Responses to Comments  
Final Supplemental Environmental Impact Report/  
Environmental Impact Statement

# Bel Marin Keys Unit V Expansion of the Hamilton Wetland Restoration Project

April 2003

Figure 4-8  
Schematic of Habitats by Tide Levels

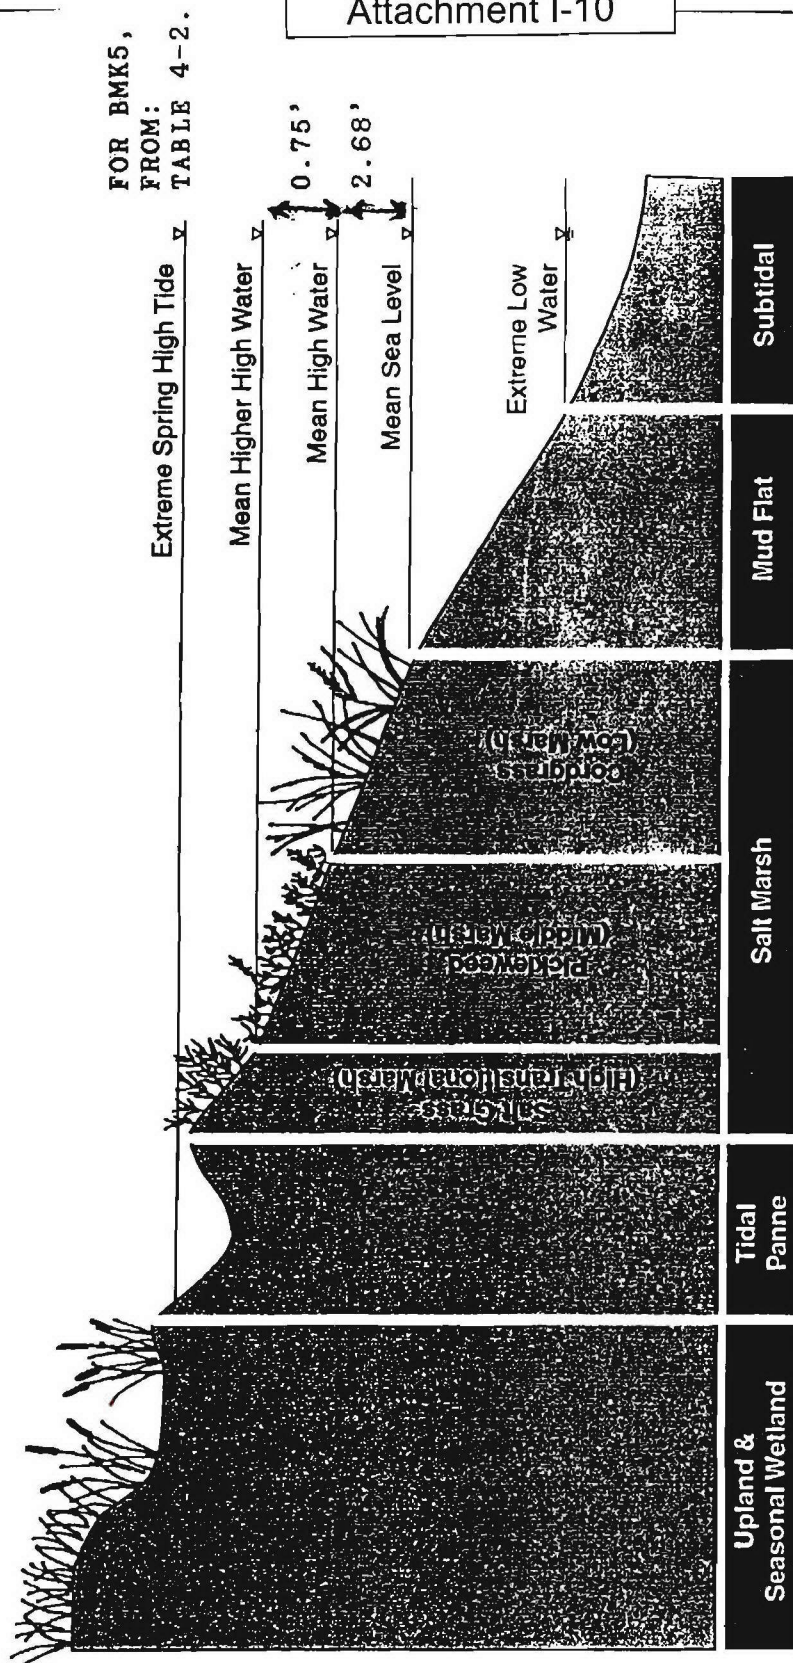
To establish TSM on the whole 849 acres would require the entire area to reach equilibrium, with tidal action and after settling, as tilted planes at the right elevation and each plane with no more than 3.43' change in elevation to include both Low and Middle TSM. (See above Table and Figure 4-8, included on next page, pg 3.) Large depressions must also be absent because ponded salt water will not yield the desired habitat. In the FEIR please explain how all 849 acres could be expected to form "tidal marsh" with the above constraints.

Please provide details for establishing Middle TSM (Pickle Weed - Harvest Mouse Habitat) within the elevation range shown on the above Table. How will the exact elevation and elevation change of less than 1 foot be maintained over the area proposed given tidal and wind action? How will the exact amount of settling be determined and accounted for? What will or can be done if the calculated elevations and/or amount of settling need adjustment after the area is flooded? Please quantify the Middle TSM area and the Low TSM area that will be established at project maturity. Will the area of newly created assessable Harvest Mouse Habitat exceed the area lost during the proposed restoration? Please specify habitat areas before and after restoration. Will new habitat meet the 3 for 1 requirement? Please provide documented evidence to show the proposed Tidal Wetland Design method described on pg 3-19 will actually yield 100% of the desired tidal marsh areas after settling. If not 100%, what percentage can be expected with certainty, based on past restoration?

If documented evidence does not support the project restoration scenario, then I propose that a more likely scenario: tidal erosion and silt deposition will establish an "equilibrium length" (EL) of TSM perpendicular to any existing or new levee. (See Figure 4-8, next page, pg 3.) EL can be determined if it is not known or published. Any tidal area beyond the EL limit will not be TSM habitat, it will be mud-flats.

As noted in the response to Comment I-10.2, the alternative marsh formation scenario is not likely to result in the same amount of tidal marsh on the site, and thus would not meet the project's goal and objectives.

SOURCE: Environmental Science Associates, Inc.

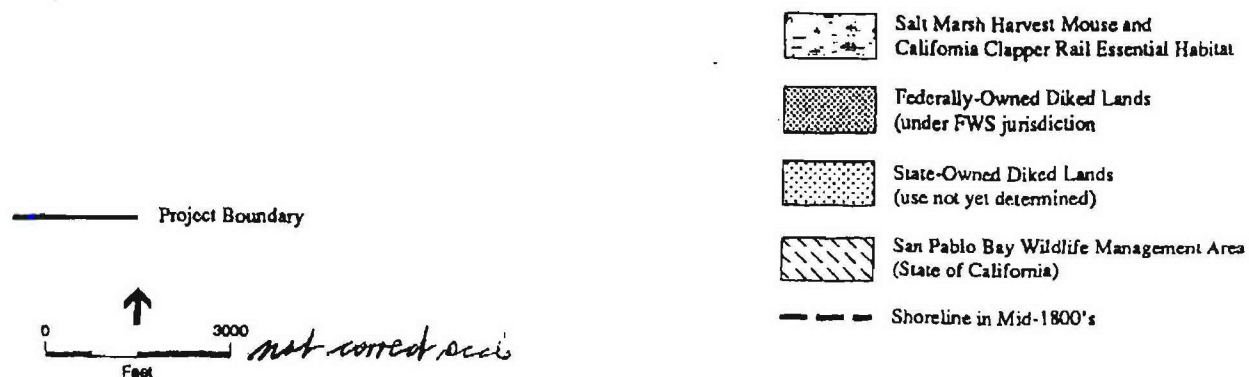
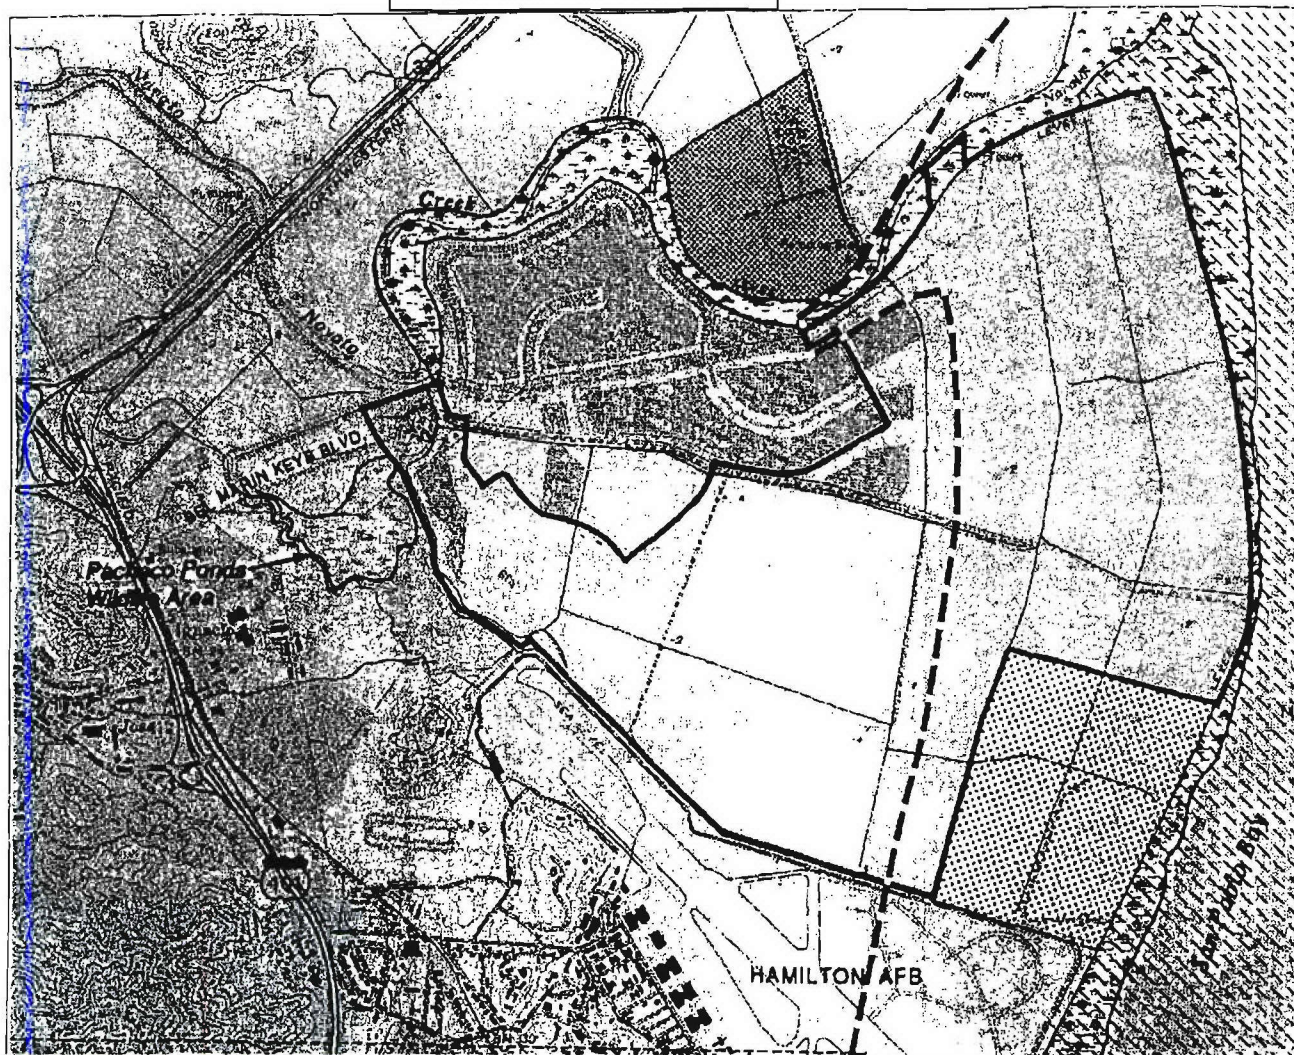
In the FEIR/S please reevaluate the mid-1800's shoreline alternative described above using the information developed from Section I. Please also discuss the following advantages of placing the new outboard levee at the mid-1800's shoreline location:

1. May provide essentially the same tidal salt marsh area as Alternatives 1&2. See Section I.
2. Provide the BMK4 300-acres F-2 ponding requirement.
3. Provide additional area to expand ponding for the Pacheco Pond overflow to provide additional flood control for the City of Novato if necessary.

- 1) As noted in response to Comment I-10.2, the commenter's suggested alternative marsh formation scenario makes no provision for conditions favorable to natural sedimentation to achieve marsh elevations. The alternative mentions no specifics regarding lowering of outboard levees, internal peninsulas, breaches, or other details. Thus, it is speculative to assert that it would result in the same tidal salt marsh as Alternatives 1 and 2 or not.
